Addendum One

June 28, 2012

Project Name & Number: East Energy Chiller I – Cooling Tower Addition/H27-I967  
Pre-Bid, June 19, 2012 @ 10 am

PROJECT TITLE:  
 EAST ENERGY CHILLER 1  
 COOLING TOWER ADDITION  
 STATE PROJECT NO.: H27-1969  
 University of South Carolina

**Cooling Tower Location Plan**  
Scale: 1/8" = 1'-0"

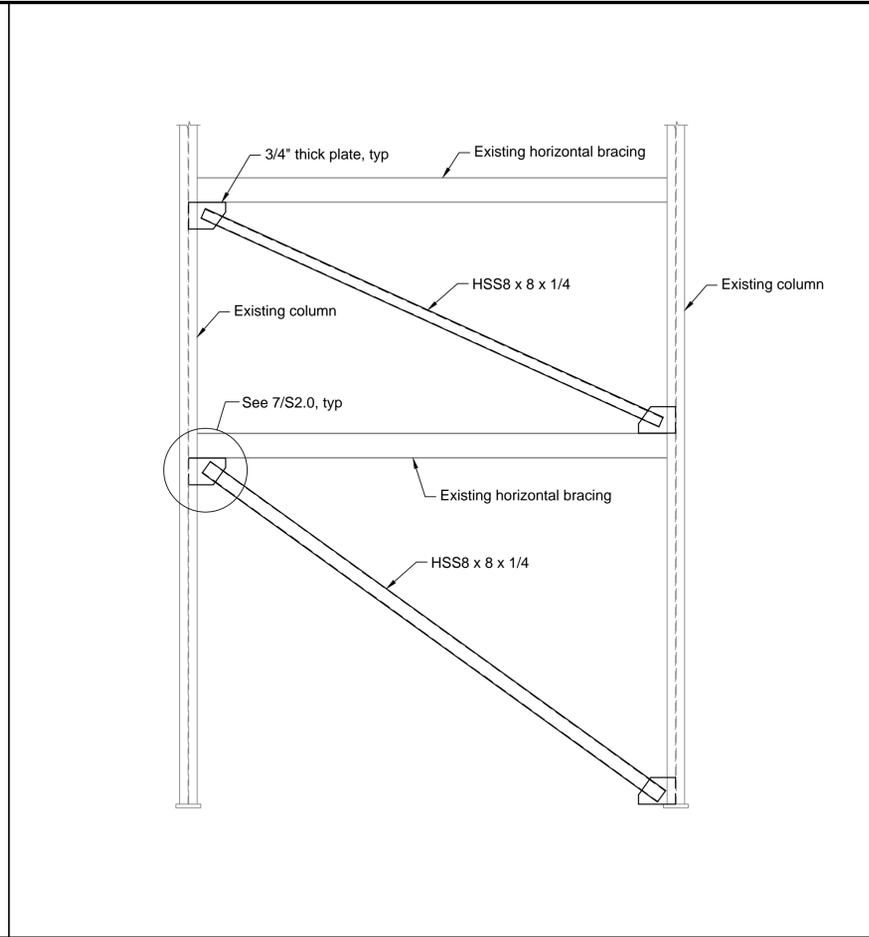
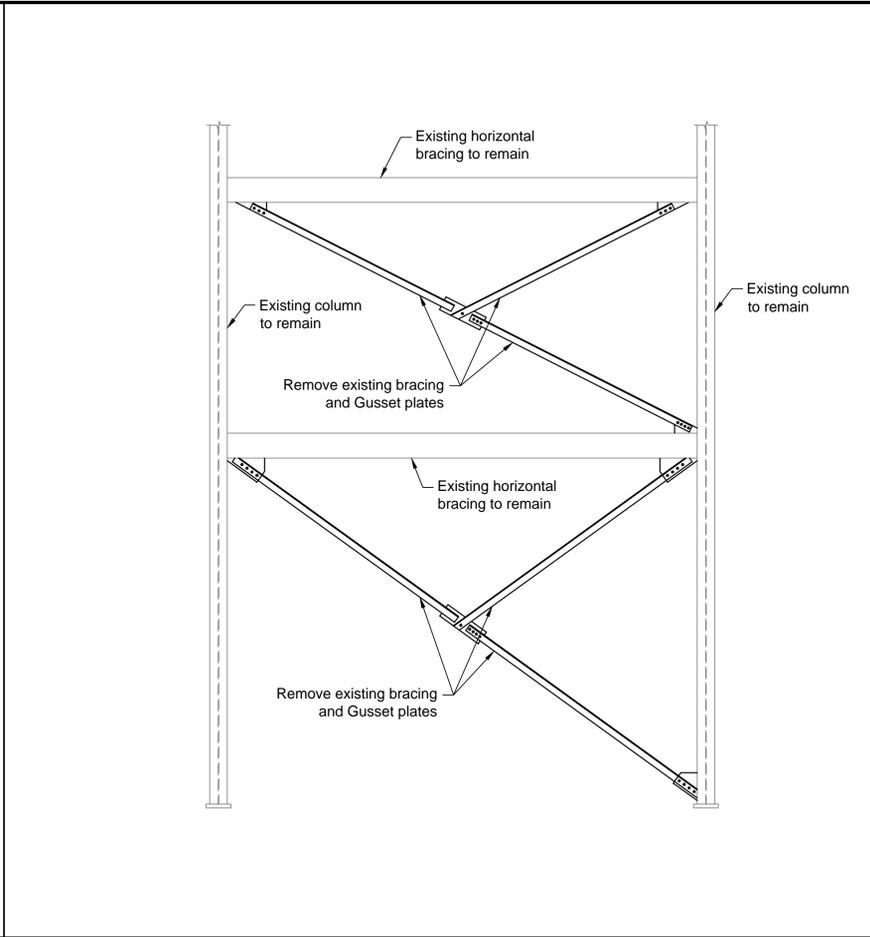
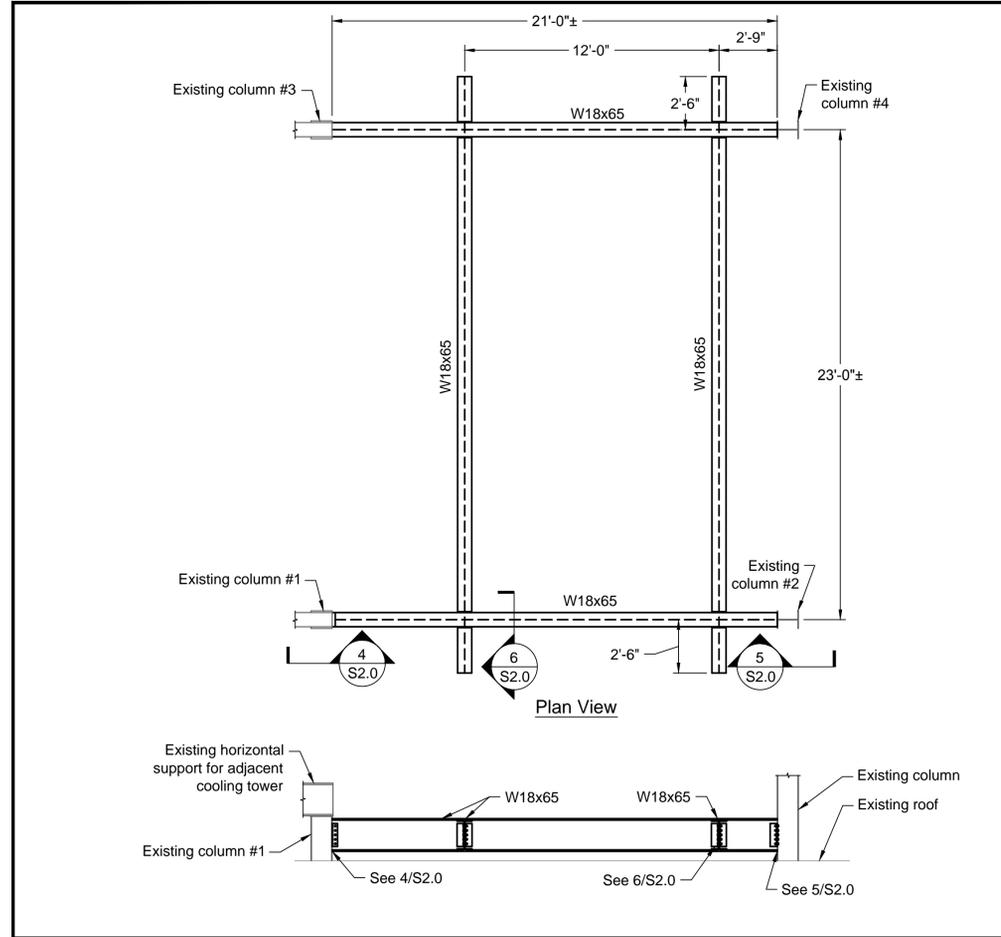
| 11.             | <u>Revision:</u> Reference Drawing S1.0, Cooling Tower Location Plan. This plan revises the structural tower support in order to allow a level basin depth with the existing towers.                      |

S2.0  
Sheet Number  
June 25, 2012  
Date

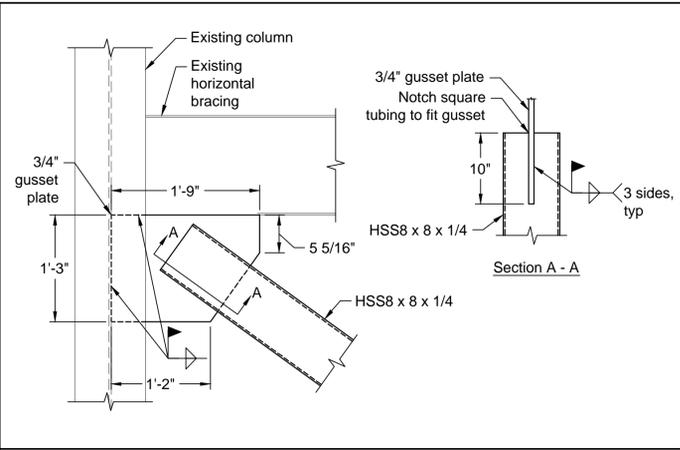
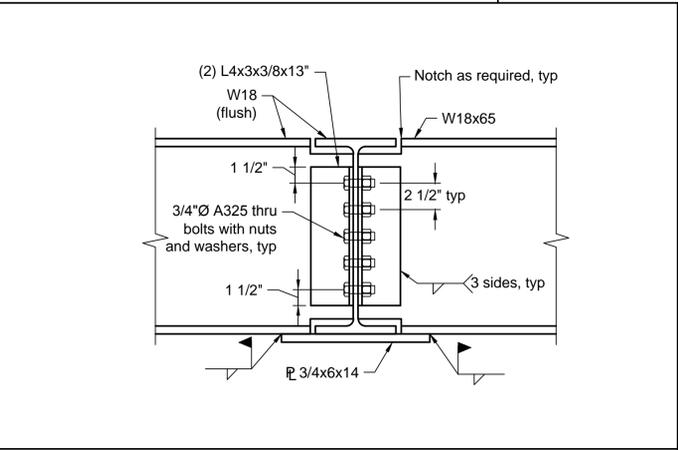
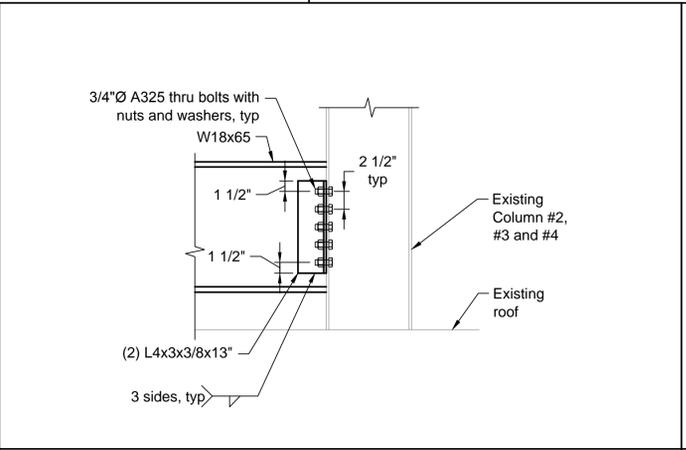
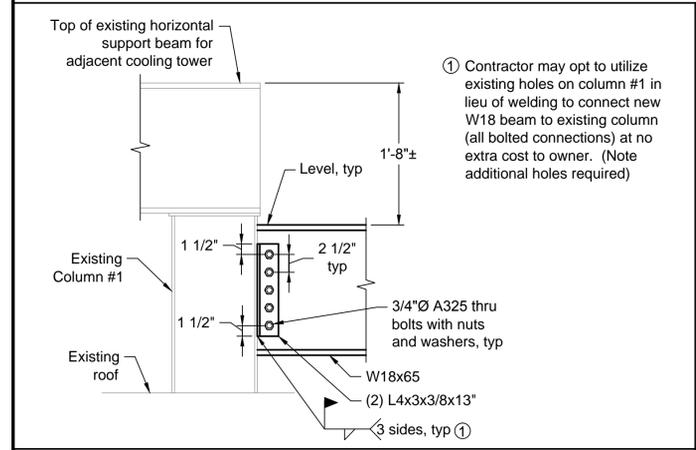
| 12.             | <u>Revision:</u> Reference Drawing S2.0, Details. This plan revises the structural tower support.   |

**1** ROOF PLAN  
 M-2 SCALE: 1/8" = 1'-0"

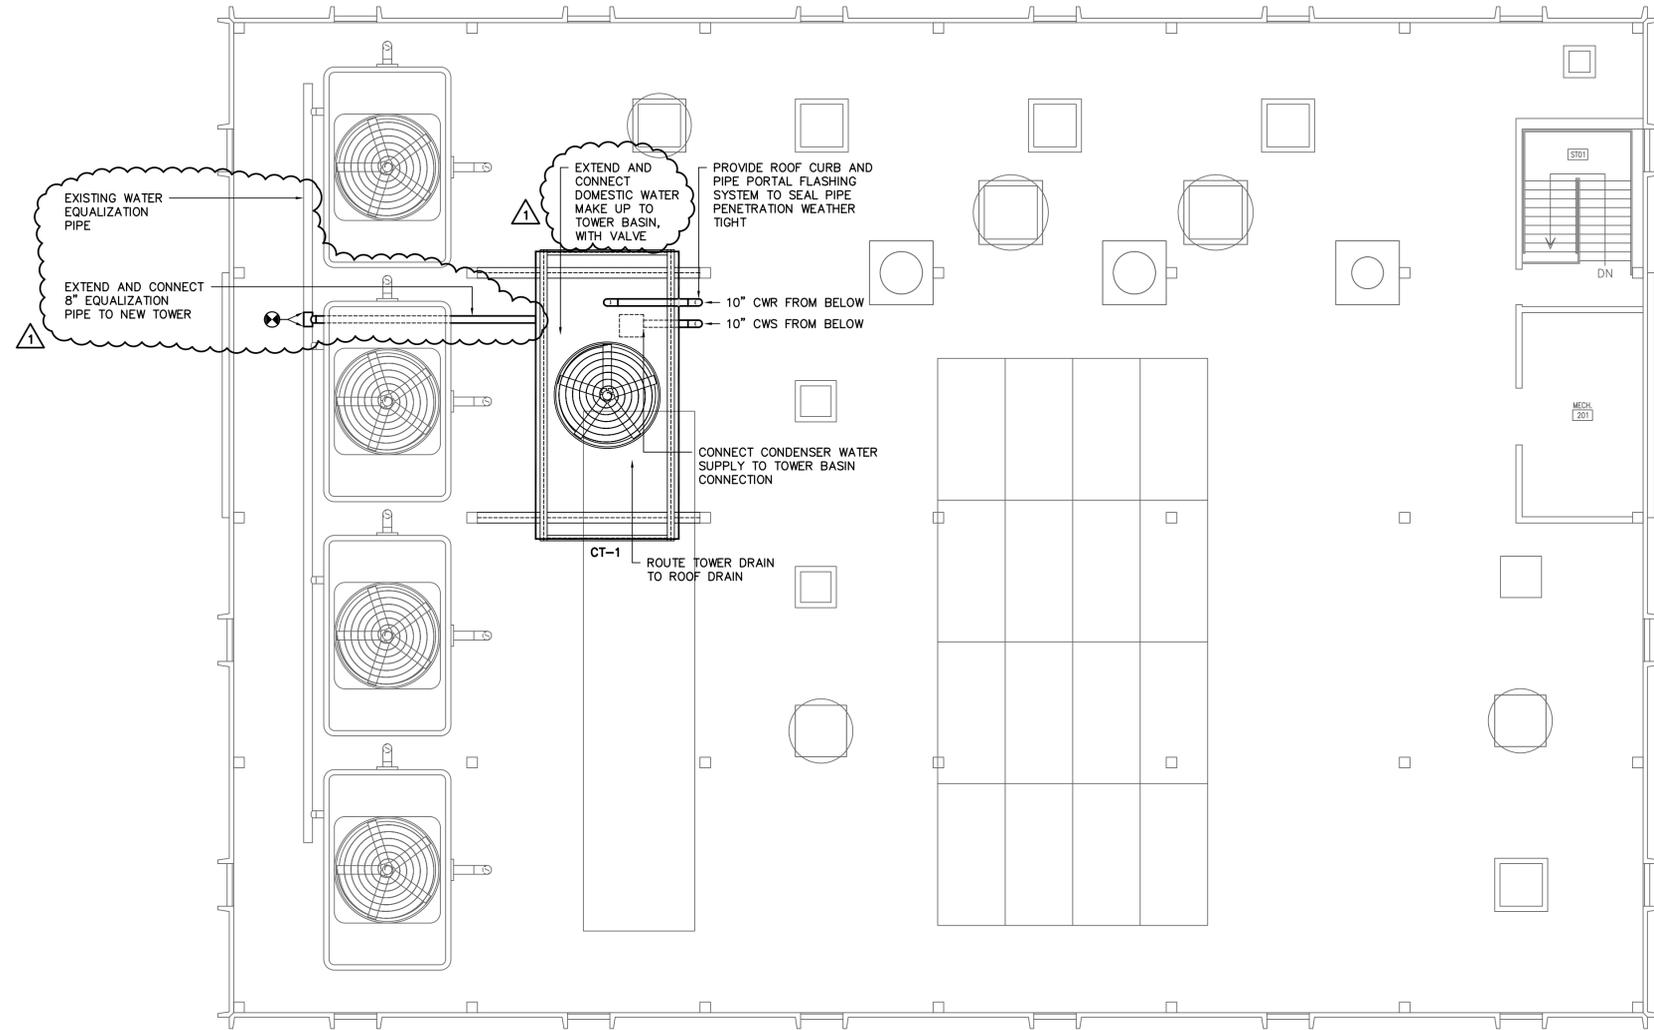
| 13.             | <u>Revision:</u> Reference Drawing M-2, Roof Plan. This plan adds an equalization pipe to the existing equalization pipe at the existing towers. This also notes the new valve at the water make up line. |

4.	<u>Clarification:</u> Make up water is indicated to the tower. The make up pipe will be connected as shown but a valve will be provided to shut the water off. Make up water is supplied via the common header.
